TRAILS AT OVERLAND VISION FILING NO. 1

JR RESPONSE: UPDATED TO MATCH COA ITEM #4

TRAILS AT OVERLAND RANCH - SITE PLAN 1

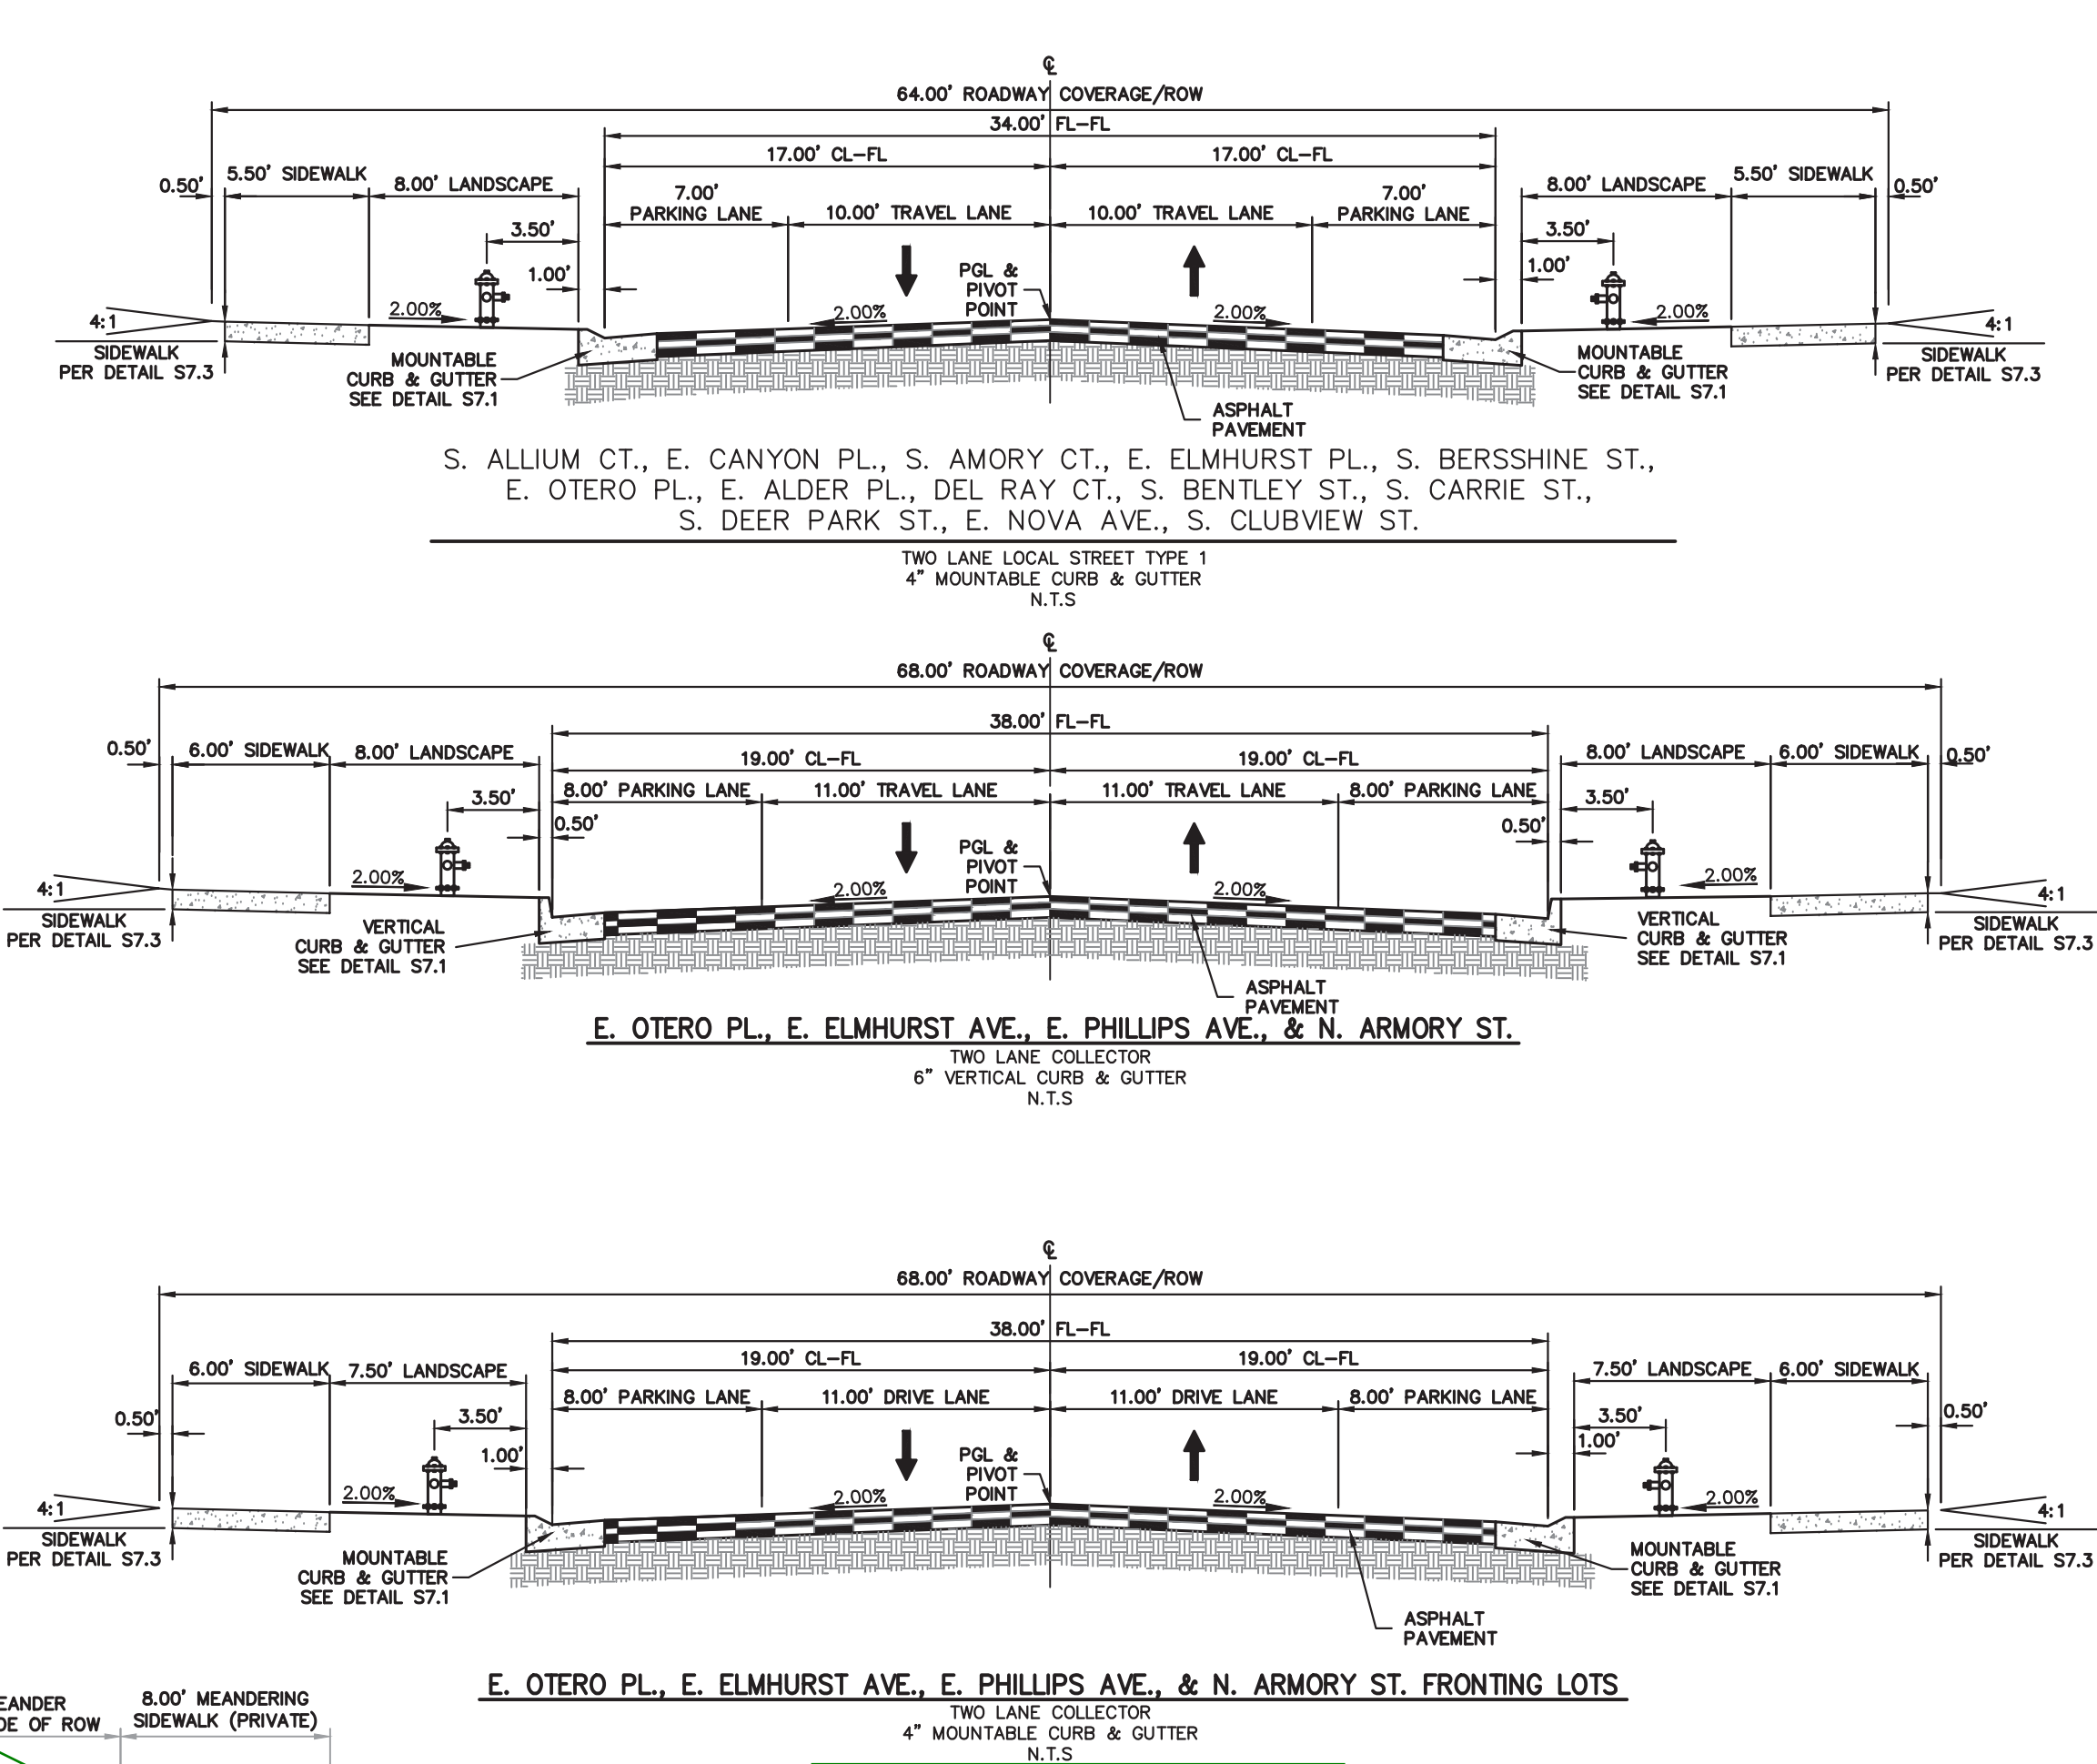
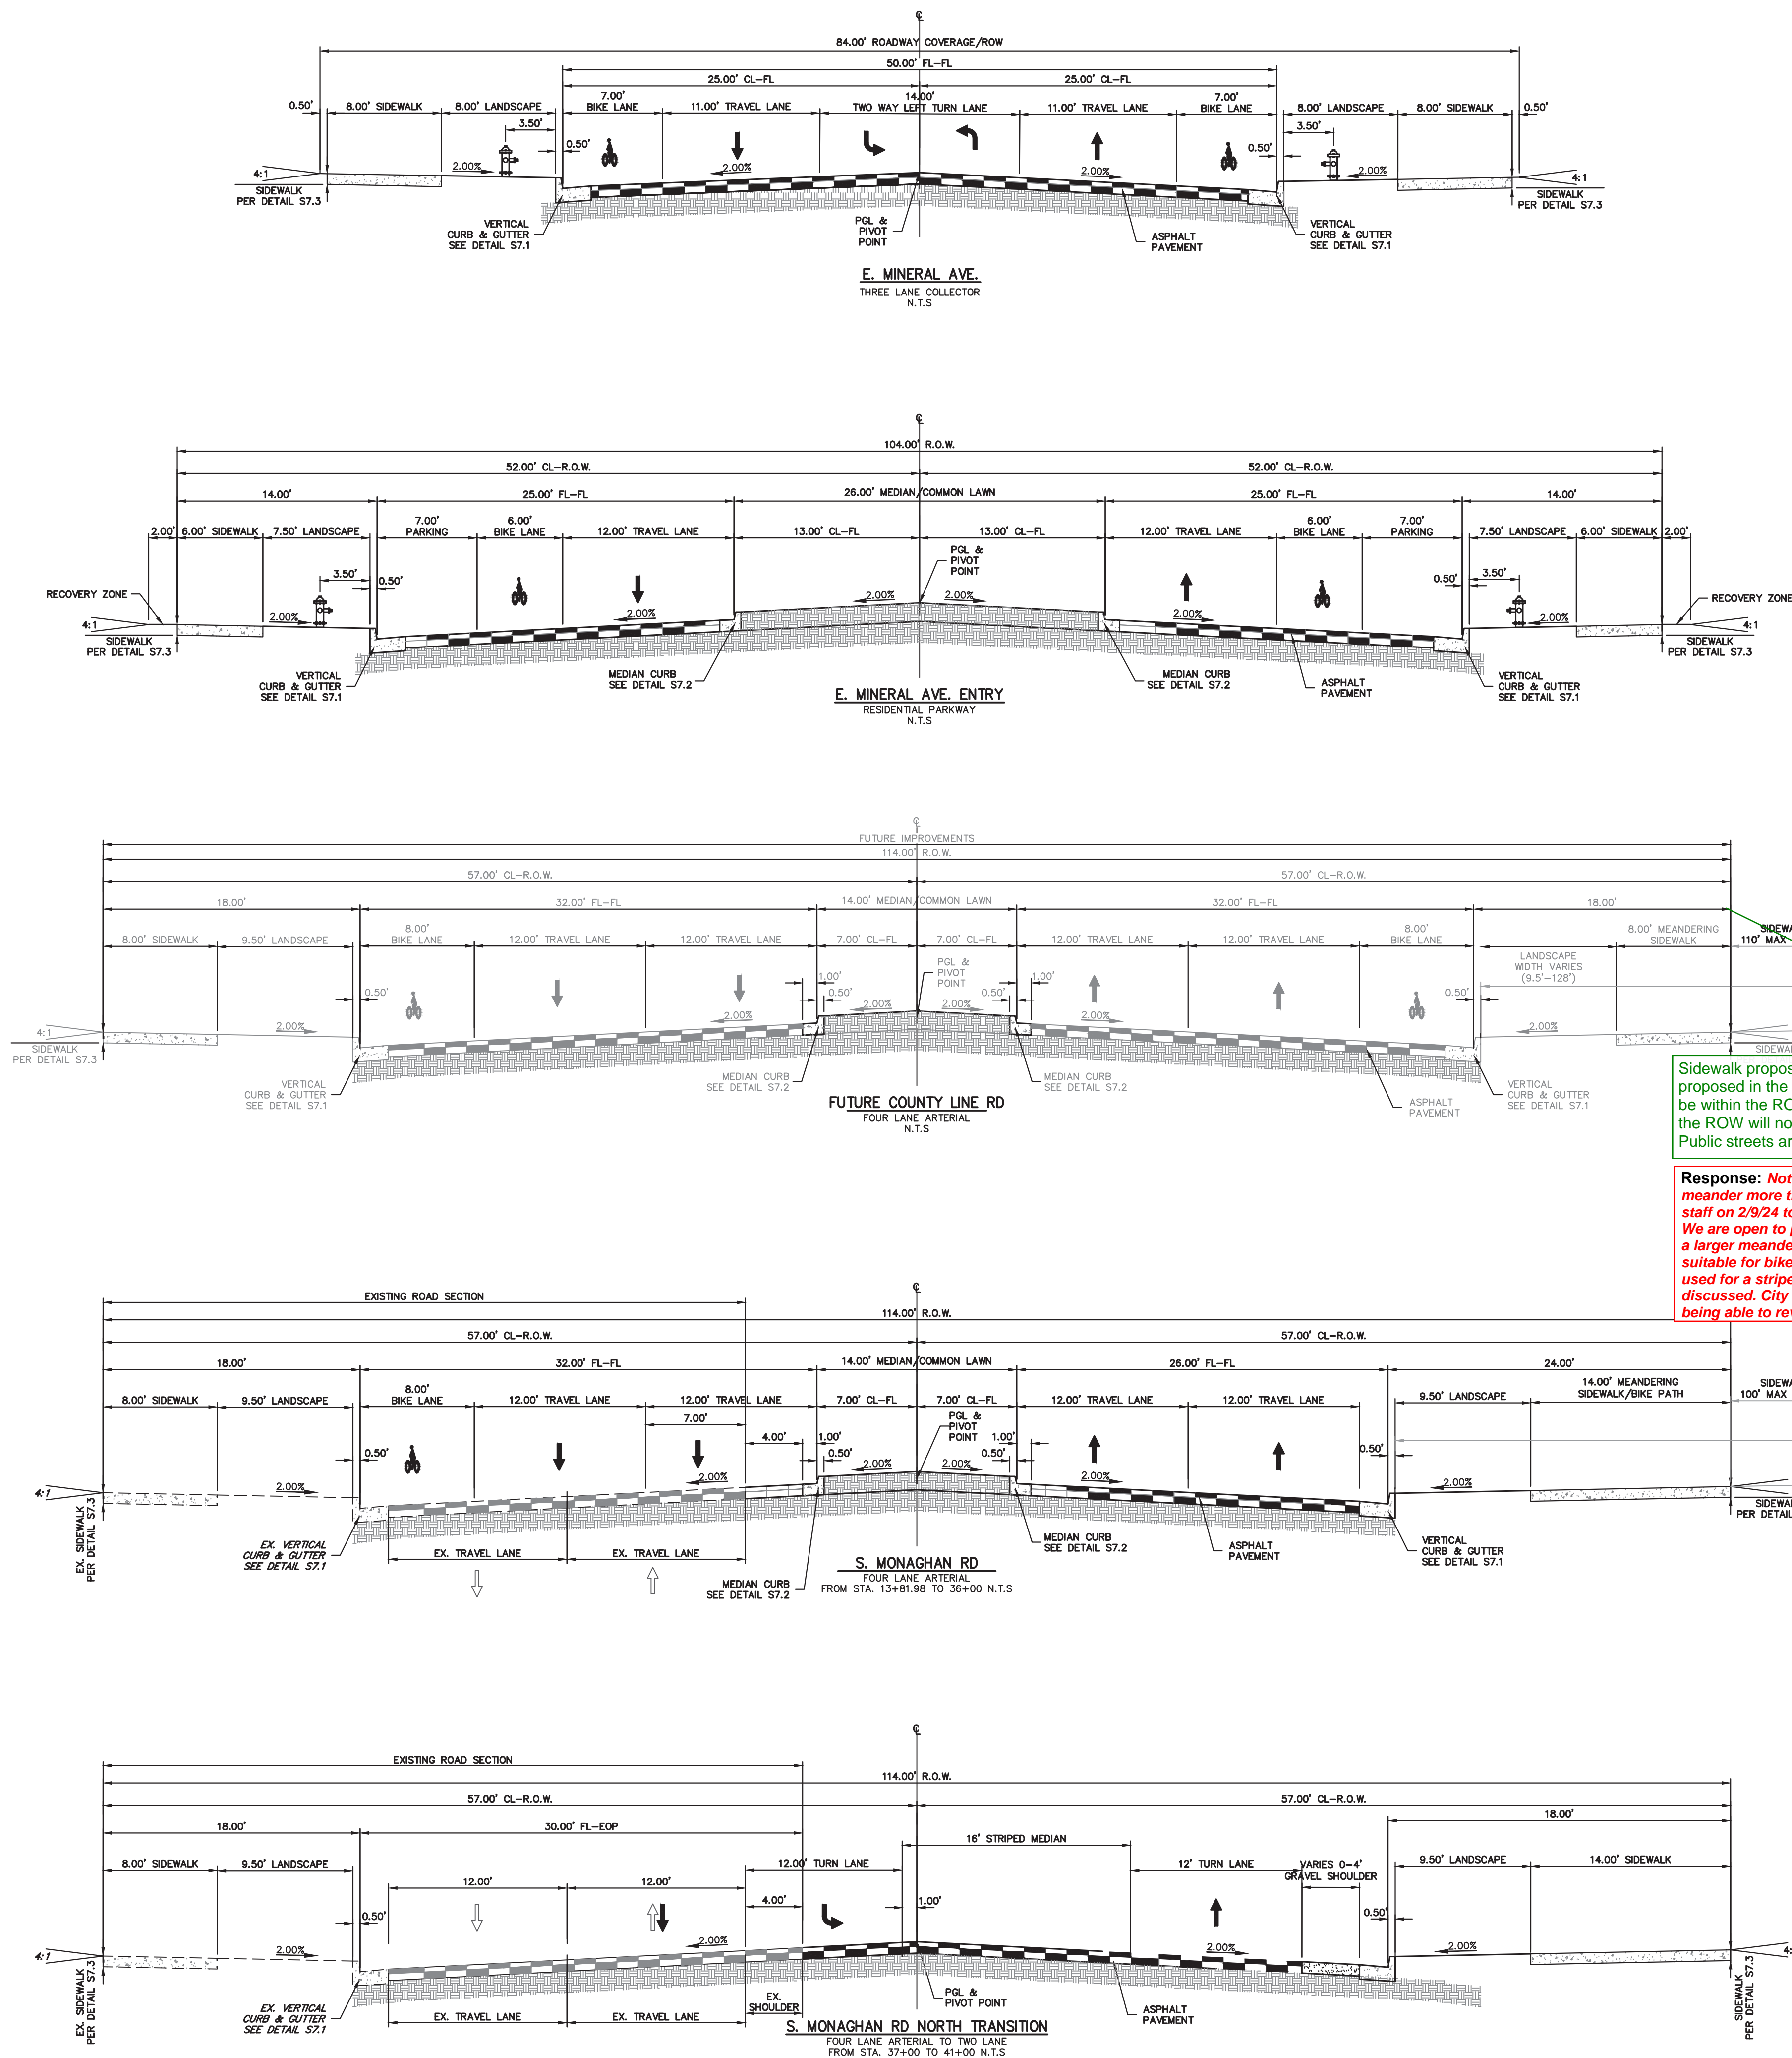
Typical. Where steep slopes abut trails, a swale may be needed to intercept and convey nuisance flows on the upslope side of the trail.

Response:
Noted. We will keep a close eye on this as we progress into construction documents. Currently, the upstream of this trail is sheet flowing fairly smoothly and is not substantially concentrated at any one location. If during CD level design areas of concentrated flow develop to any extent we will add appropriate swales and culverts. If possible, we may also allow a small grade buffer on upstream side of trail.
